Submission to the Independent Planning Commission

Glebe Island Concrete Batching Plant and Aggregate Handling Facility SSD 8544

Part 2

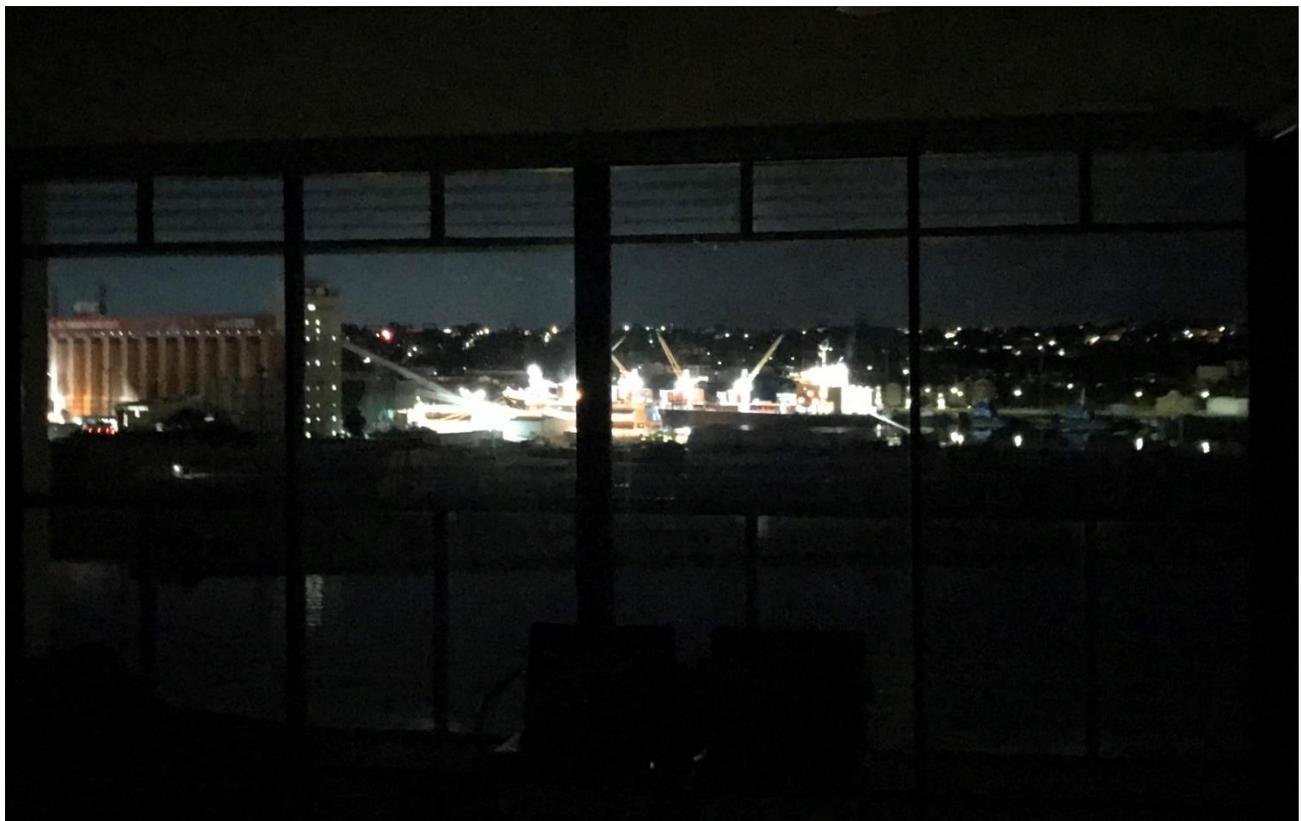
This photo from our apartment shows that that statement is simply incorrect. The site is in darkness. It is not within “a well-lit context” with “existing floodlights installed on adjoining sites”. You can see from this photo that the Sydney City Marine buildings are

in darkness, as are the Glebe Island silos. Significantly, the latter are subject to a lighting curfew. There are no floodlights from the ANZAC bridge down on the site. This is yet another example of the glib, self-serving assertions made in the assessment that do not bear scrutiny.

The major sources of light in the above photo are the lights of Annandale beyond the Sydney City Marine buildings and the area to the right near GI Berth 7 on the other side of Glebe Island.
